Office Action Summary

10/675,820

MICHELSON, GARY K.

DETAILED ACTION

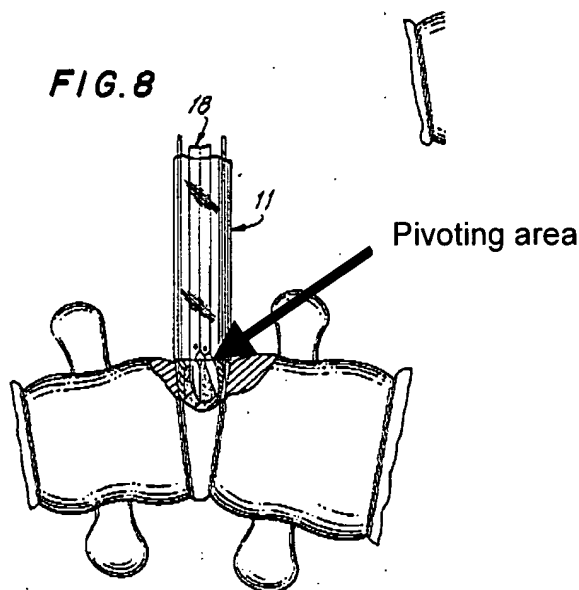
Claims 1-28 are rejected under 35 U.S.C. 102(b) as being anticipated by Jacobson (US 4,545,374). Jacobson discloses a spinal device comprising a body (10) having a first end (that heads into the vertebral area) and a trailing end (opposite),

wherein the device has a pivotal relationship between the two portions (compare item 10 in Figs. 4 and 5; also element capable of pivoting in drawing).

The first and second portions are also at least partially arcuate (see Figs. 12 and 13) which define an opening and a disc-space therebetween that may also be considered generally circular. In both the open and closed positions, the first and second body portions (10 and 10) are generally parallel, both in the closed and open positions (see Figs. 4 and 5). The two portions are also adapted to allow for a surgical instrument to pass through, and that are also at least partially arcuate (see Fig. 8). Depending on the rotation of the device in use, the first and second portions may be oriented towards the adjacent vertebral bodies of the patient's spine. The disc space is also considered in view of the full length of the device as in forming a tube.

Jacobson also discloses a device that has a body that is generally oval and elliptical, and likewise may also be considered generally circular, along the length and also viewed as a cross section (Fig. 13).
